Product Update SER 15-004

Spider KnockDown Mod 710026-1 Caster Assembly June 30, 2015

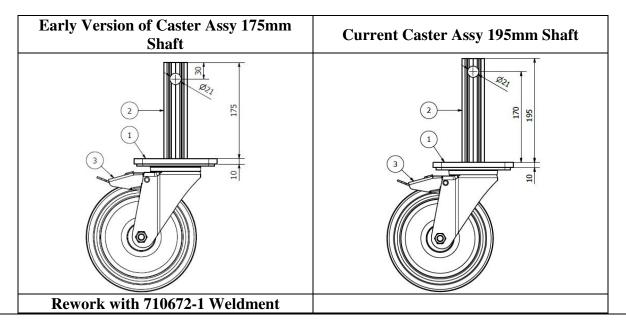
Notification Customer communication, no action required.							Optional / Notification						
Operation Communication, no action required.									iotilication				
PRODUCT N	ODELS A	FFECTED											
SC1000/1500 SC		SC30		SC40 Zma		c Astro			ST-17 ST-19				
ST-26		ST-180		Platforms BAP				TAP		Other:			
Hoist Accessories Platform Accessories								Rigging Accessories Safety Accessories					
CONTROLLE	TCVCTEN	. ^											
COMPONENT SYSTEM Electrical			\boxtimes N	Mechanical			Safety				Other:		
Electrical				neeriamear					other.				
SUB COMPO	NENT												
	710	0026-1 Ca	ister A	Assembly with	17	5mm	shaft con	ne	ection pin hole	e w	ill not line up	,	
							ion pin h

A new version of the Caster Assembly is available that has been redesigned with a 20mm longer shaft that will allow proper hole alignment. If you have an early version of the Caster Assembly with the shaft measuring 175mm (6 7/8 in), it must be reworked the current version of 195mm (7 5/8 in). Contact Product Support to order the replacement Shaft Weldment (710672-1) to retrofit.
